Update - Proposed Updates to pittala_3ct_01a_0120

IEEE P802.3cw TF Interim Teleconference Meeting

October 11, 2021

Proposed Update to Pittala_3ct_01a_0120, Slides 5-9

Fig. 1 Measurement setup for OSNR penalty vs EVM for non-equalizable noise like impairment.

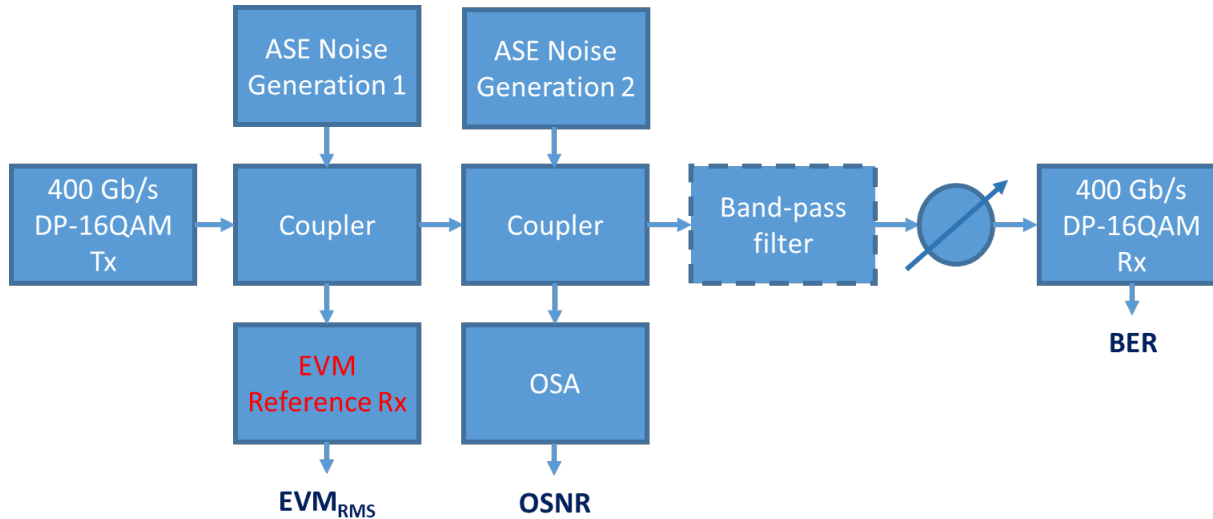
The measurement setup in Fig. 1 (for noise like impairment) and the one in Fig. 2 (for non-equalizable or equalizable impairments) should be used to test if the following parameters can be covered by EVM:

If measuring non-equalizable noise-like impairment using the setup in Fig. 1 the following steps are used:

- 1) OSNR Penalty Testing
 1. Without ASE noise generation 1, adjust the ASE noise generation 2, to get the considered pre-FEC BER of $1.25e-2$; the OSNR value is measured ($OSNR_0$). Capture the optical waveform at the output of the Calibrated Coherent Receiver, which will be used to calculate EVM_{MAX0}

2. OSNR Penalty - The OSNR Penalty Testing should cover at least 0-2.4dB OSNR penalty and should consists of at least 7 points. Each point should be obtained tuning the impairment under consideration such to get a point-to-point variation of not more than 0.4dB OSNR penalty.

- a) Introducing ASE noise generation 1, the pre-FEC BER is changed (not $1.25e-2$ anymore). Capture the optical waveform at the output of the Calibrated Coherent Receiver.

- b) Adjust the ASE noise generation 2, to set pre-FEC BER at $1.25e-2$ again, then turn-off ASE noise generation 1 and then the second OSNR value is measured ($OSNR_1$), the OSNR penalty is ($OSNR_1 - OSNR_0$).

3. Change the ASE noise generation 1 and repeat step 2. Capture the optical waveform at the output of the Calibrated Coherent Receiver and measure the OSNR value as noted.

- 2) EVM Analysis
 - a) For each optical waveform captured, EVM_{MAX} is calculated with “Digital Signal Processing” as per current IEEE P802.3cw draft
 - b) The curve of OSNR penalty versus EVM_{MAX} is obtained.

Fig. 2 Measurement setup for OSNR penalty vs EVM for non-equalizable (circle-like noise) or equalizable impairment(s).

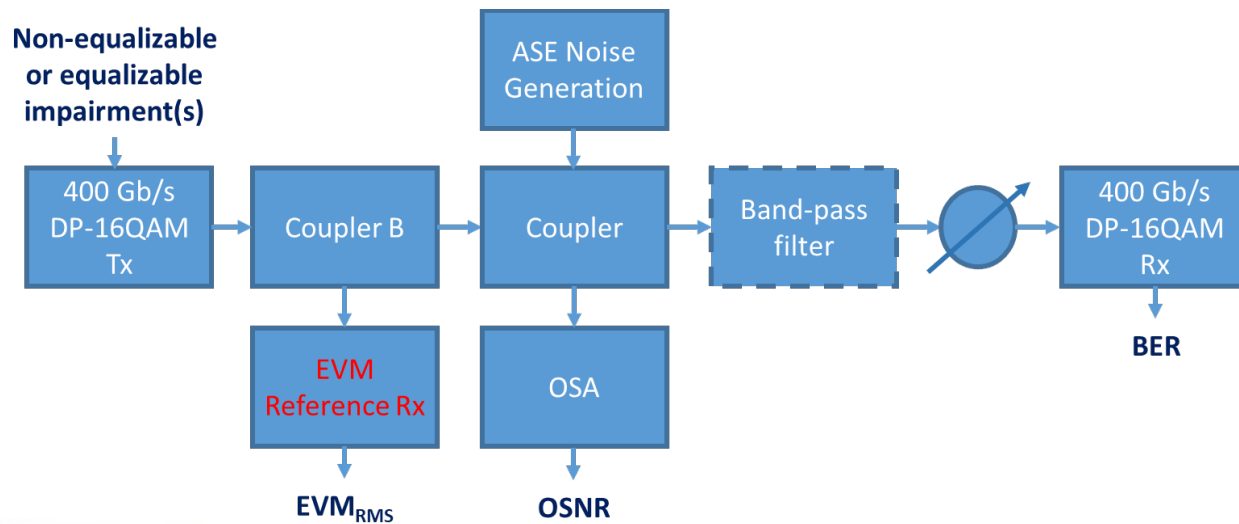
Measurements based on setup in Fig. 2

It is preferred that measurements are obtained independently for each parameter, i.e as the effect of varying one parameter is being measured the other parameters remain unchanged.

Using IQ offset as an example the procedure is:

- 1) OSNR Penalty Testing
 - 1) Adjust the ASE noise generation, to get the considered pre-FEC BER of $1.25e-2$; OSNR value is measured ($OSNR_0$). Capture the optical waveform at the output of the Calibrated Coherent Receiver, which will be used to calculate EVM_{MAX0}

- 2) OSNR Penalty
 - a) Modify the transmitter to give a certain value of IQ offset and Capture the optical waveform at the output of the Calibrated Coherent Receiver.

- b) The pre-FEC BER is changed (not $1.25e-2$ anymore), Adjust the ASE noise generation, to set pre-FEC BER at $1.25e-2$ again, then the second OSNR value is measured ($OSNR_1$), the OSNR penalty is ($OSNR_1 - OSNR_0$).

- 3) Modify the transmitter to give a certain value of IQ offset and repeat the b) part of step 2). Capture the optical waveform at the output of the Calibrated Coherent Receiver and measure the OSNR value as noted.

- 2) EVM Analysis
 - 1) For each optical waveform captured, EVM_{MAX} is calculated with “Digital Signal Processing” as per current IEEE P802.3cw draft
 - 2) The curve of OSNR penalty versus EVM_{MAX} is obtained.

EVM Reference Rx

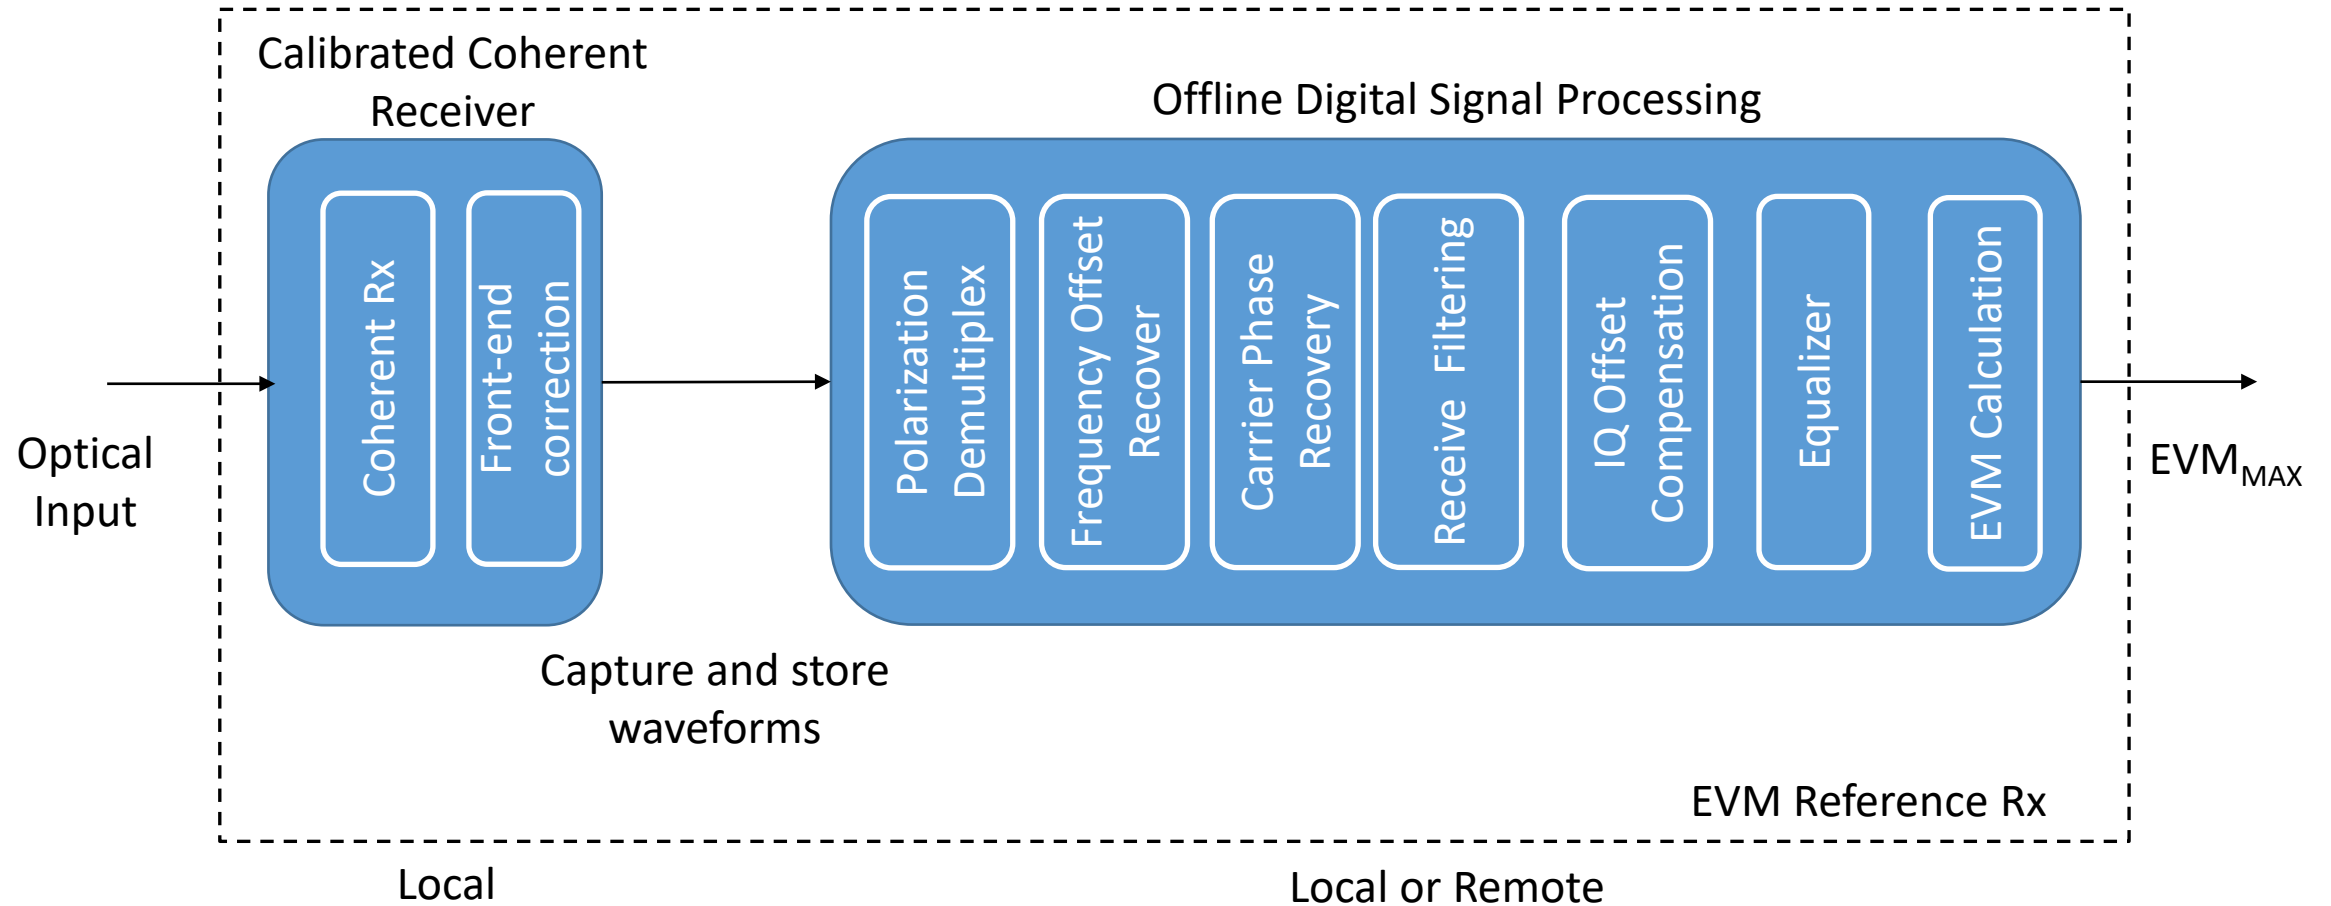
- Calibrated coherent receiver: always “local” to transmitter under test
- Offline digital signal processing: can be either “local” or “remote” to transmitter under test
